ADDENDUM

ADDENDUM NO.: #02

DATE: 02/08/2024

PROJECT: Woodhouse Ford Pro: Building Improvements

2 FIRST FLOOR PLAN - AREA B
 1/8" = 1'-0"

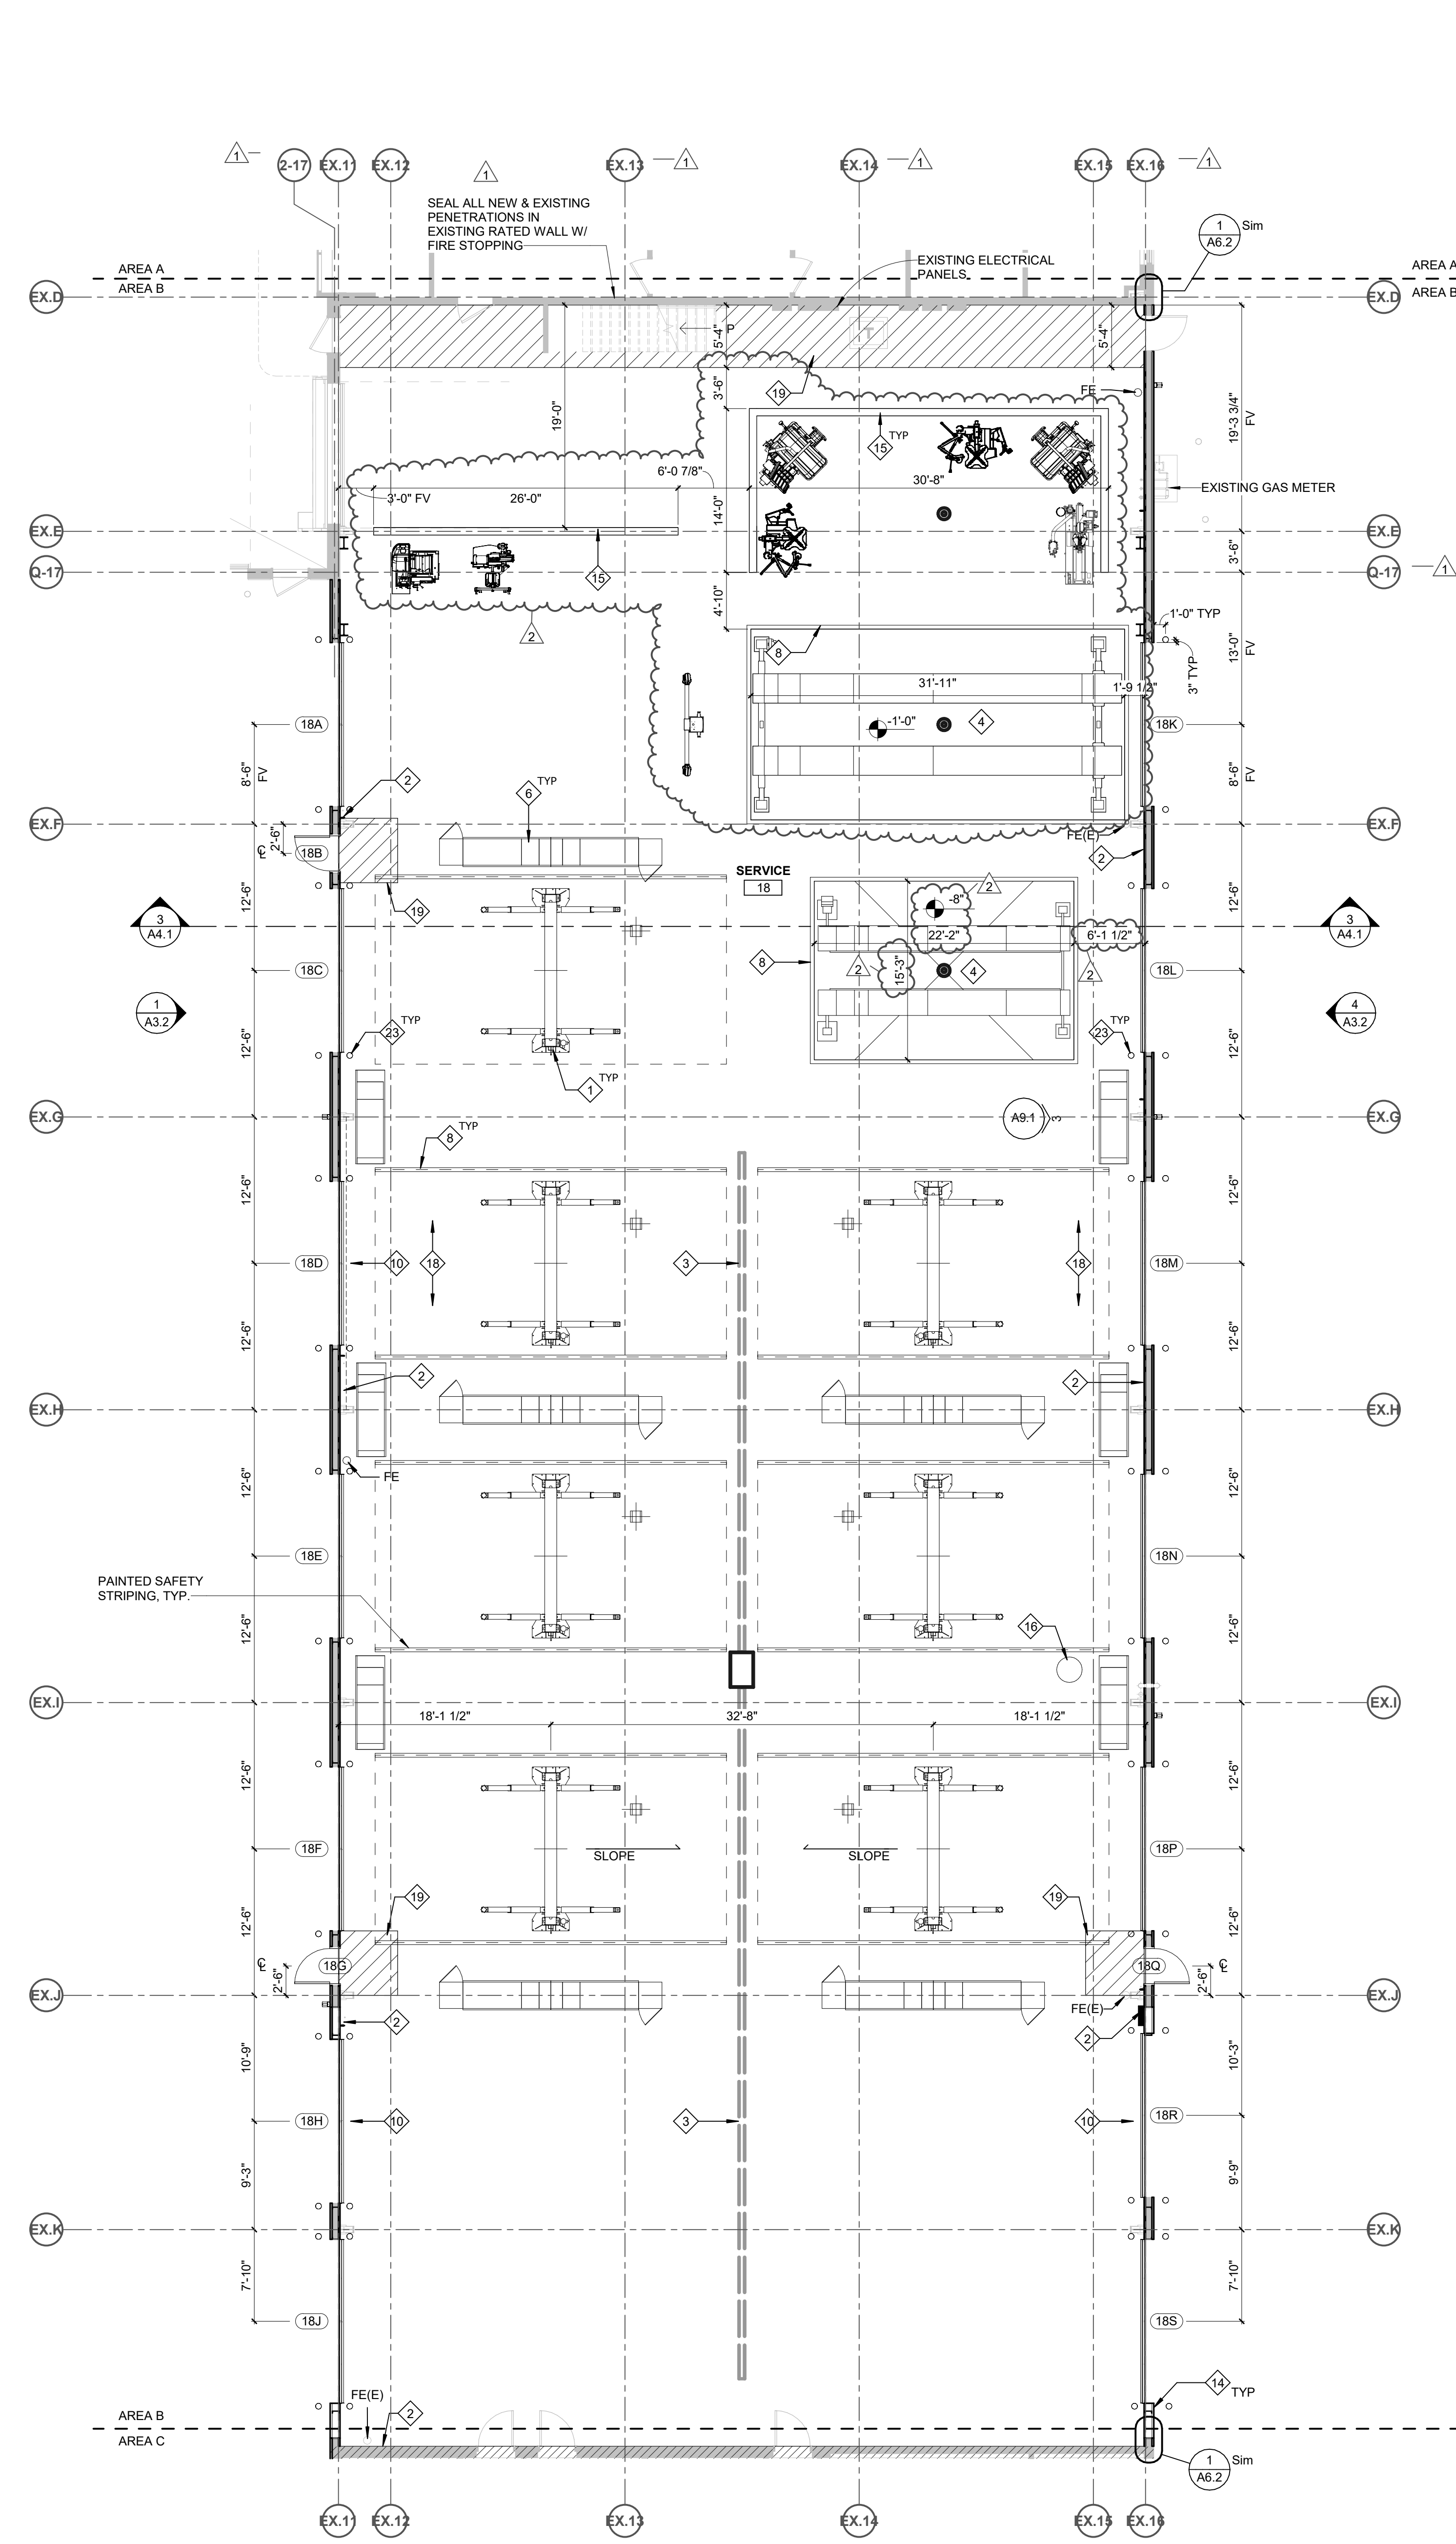
- a. 2 - FIRST FLOOR PLAN - AREA B
 - i. Added tire changing station with 8" cmu walls
 - ii. Revised other tire changing station
 - iii. Revised large pit dimensions and added pit depth elevation
 - iv. Added missing pit elevations on small pit and added depth elevation.

2 FIRST FLOOR FINISH PLAN - AREA B
 1/8" = 1'-0"

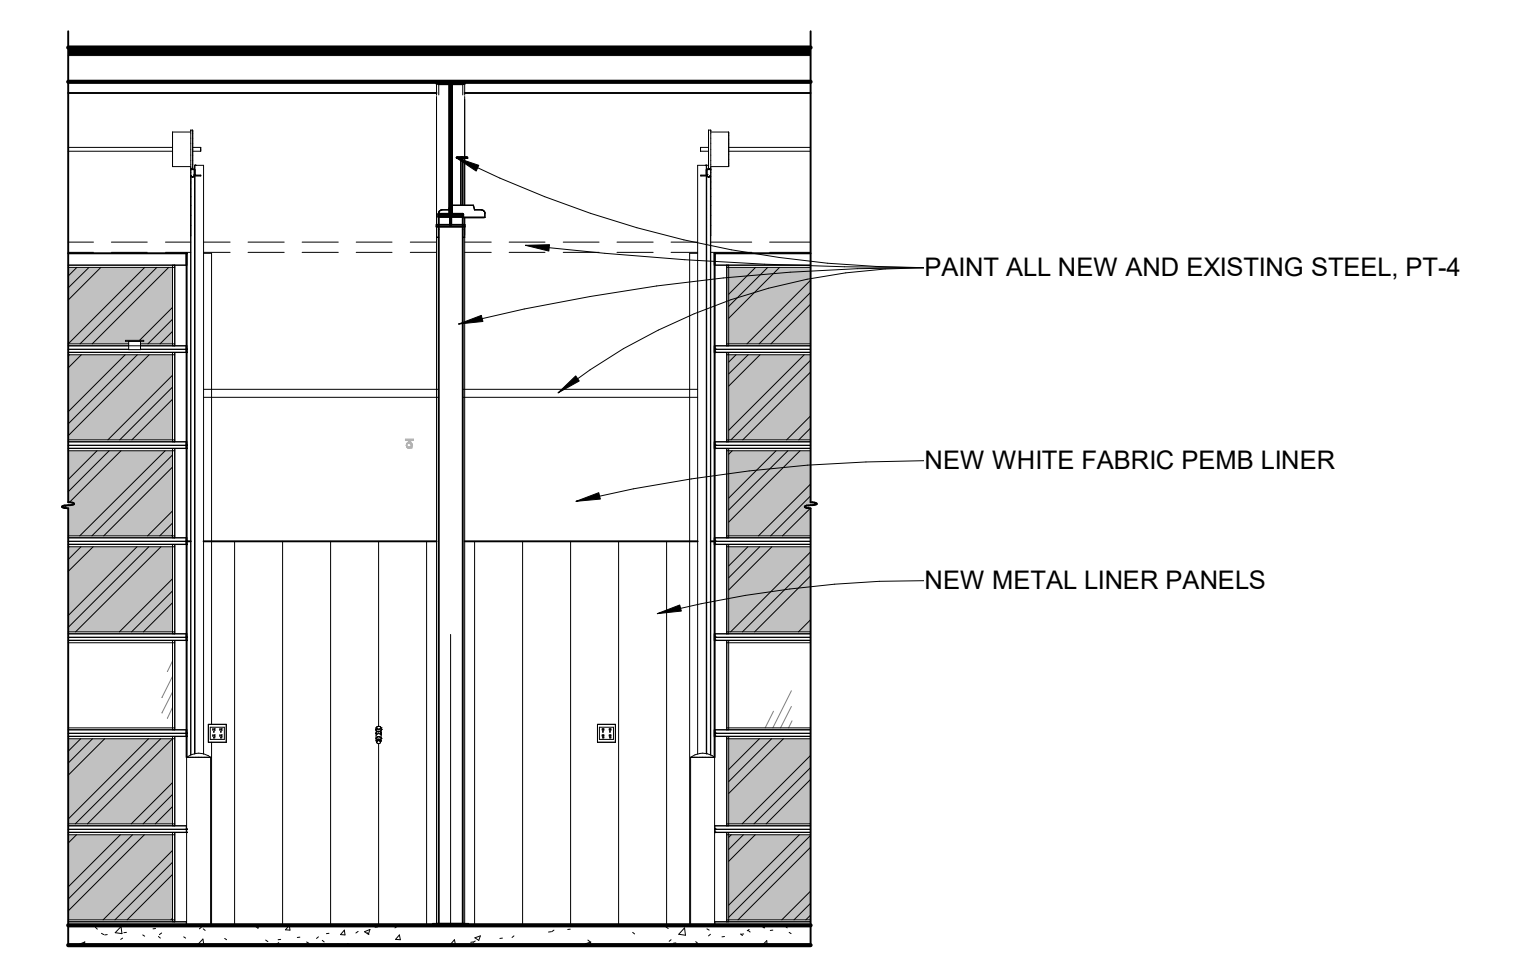
- a. Revised Alternate Notes as clouded.
- b. 2 - FIRST FLOOR FINISH PLAN - AREA B
 - i. Added additional notes to paint existing doors.
 - ii. Paint CMU half-walls as clouded.

1 FIRST FLOOR FINISH PLAN - AREA C
 1/8" = 1'-0"

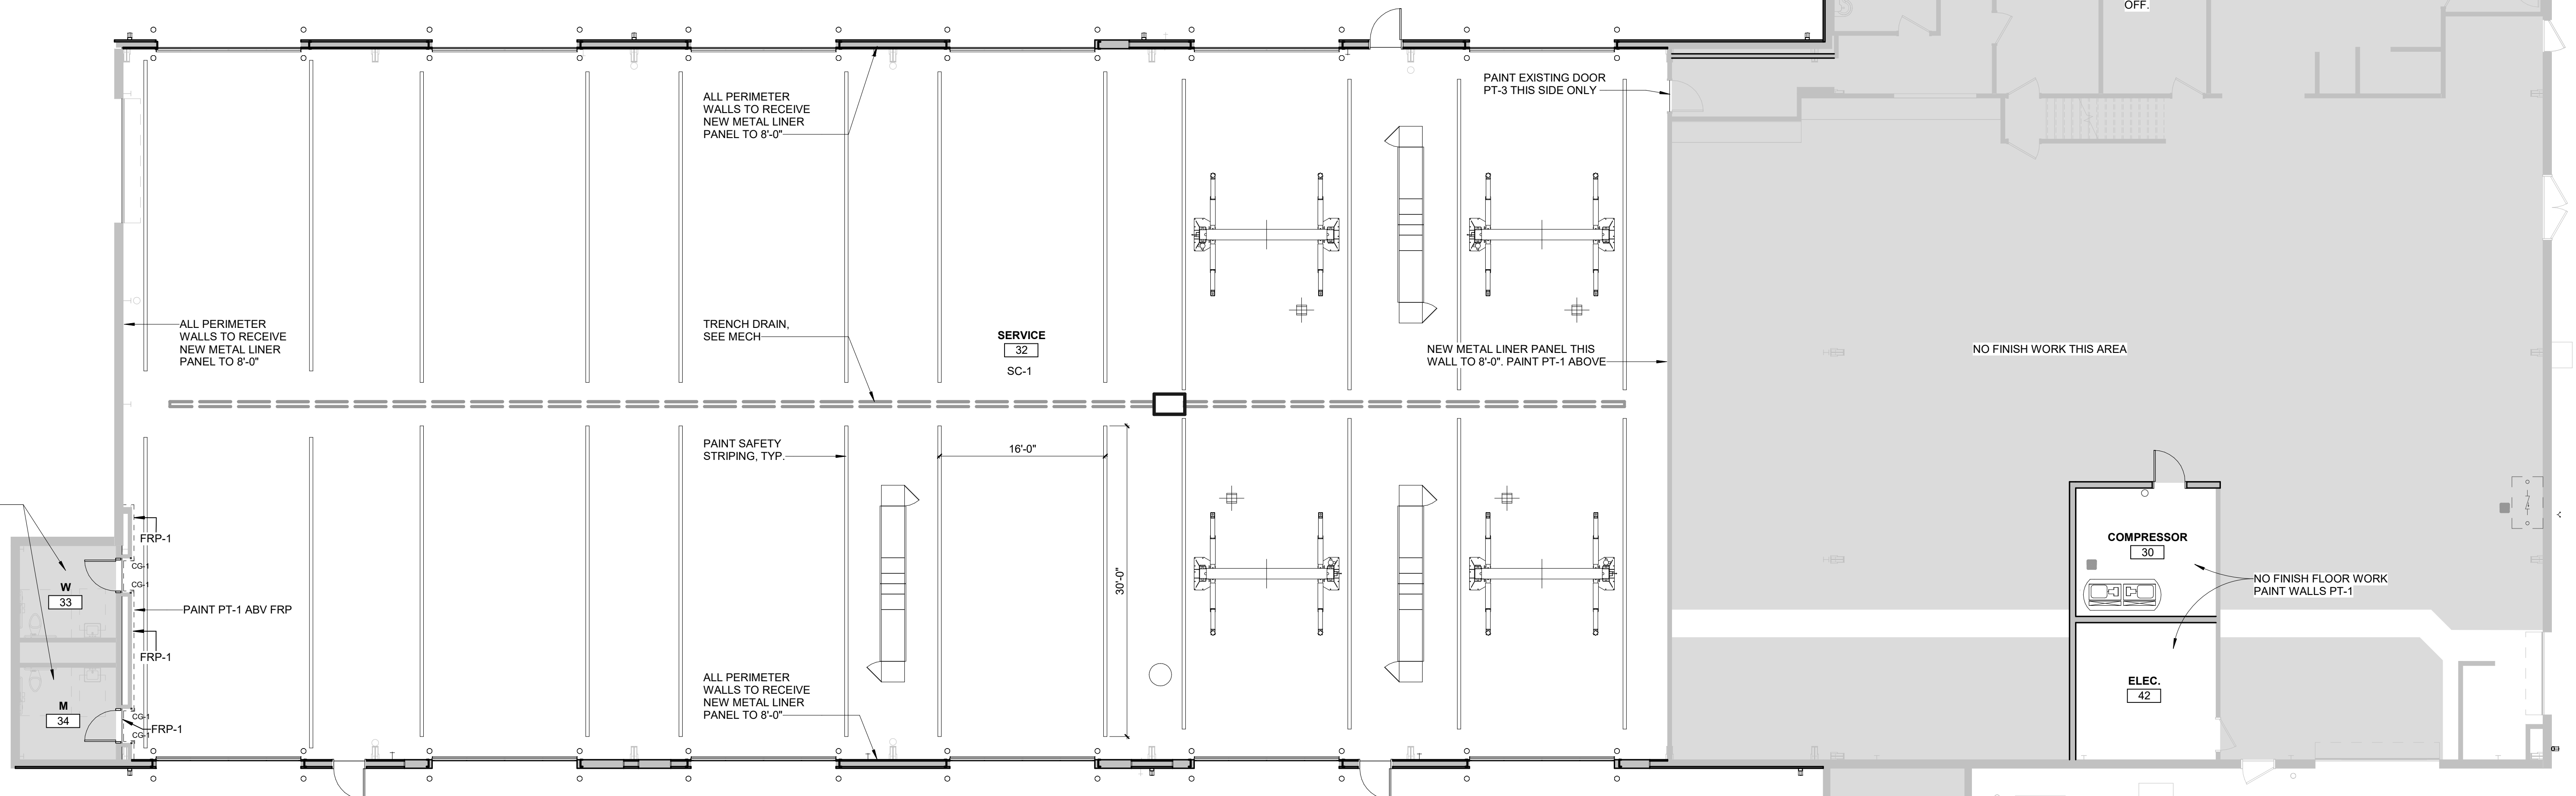
- a. INTERIOR FINISHES SCHEDULE
 - i. CPT-2 , Carpet Tile Rug, comments:
 1. Added Shaw quote and note non-skid backing
- b. 1-FIRST FLOOR FINISH PLAN - AREA C
 - i. Added notes to paint existing doors (near matchline).
